**Historical Architectural Review Board
COA Final Review Sheet**

HDC-2023-00016

Address: 616 N. 6th Street

Proposal: Legalize tile on front porch (violation correction)

Front façade of 616 N. 6th Street, 2021.
(Google StreetView)

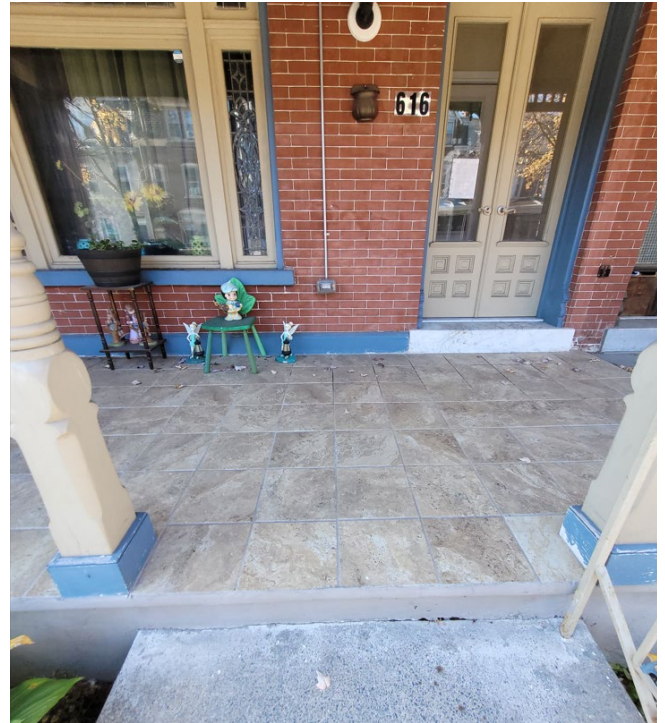
Guideline 3.7.8 notes that alternate porch materials, such as composite wood decking, may be appropriate if similar to the appearance of the original floorboards. The guideline specifically notes that ceramic tile, carpet, or cementitious coatings over wood are not appropriate floor materials. Staff contends that the tile is not an appropriate porch material whether installed over wood or concrete and recommends removing the tiles and repairing the existing concrete slab to better comply with the design guidelines.

Mr. Jordan questioned what an appropriate solution would be, noting that the concrete porch was a past violation from a developer and that the current owner then installed tile to create a second violation. He stated that it creates a very difficult situation without a clear solution. He then stated that the HARB must approve applications that meet the Guidelines for Historic Districts.

Mr. Lichtenwalner agreed with Mr. Jordan, stating that to satisfy the guidelines the HARB would need to recommend that the porch be returned to wood, but noted that that would not be a reasonable request. The HARB then discussed the possibility of removing the tile, noting that it may cause significant damage. The HARB stated that the tile on the porch did not meet the Guidelines for Historic Districts and that it would need to recommend denial of the application but added that City Council would have the authority to consider the implications of reversing the work, and whether the tile could be legalized owing to the unique circumstances.

Denial, pursuant to Chapter 3, Section 3.7 Porches & Steps.

Mr. Lichtenwalner moved to deny the application presented on 5/1/2023 for the legalization of tile on the front porch of 616 N. 6th Street, pursuant to Chapter 3, Section 3.7 Porches & Steps. Mr. Hart seconded the motion, which carried by a vote of 4-0. Mr. Encelewski abstained.
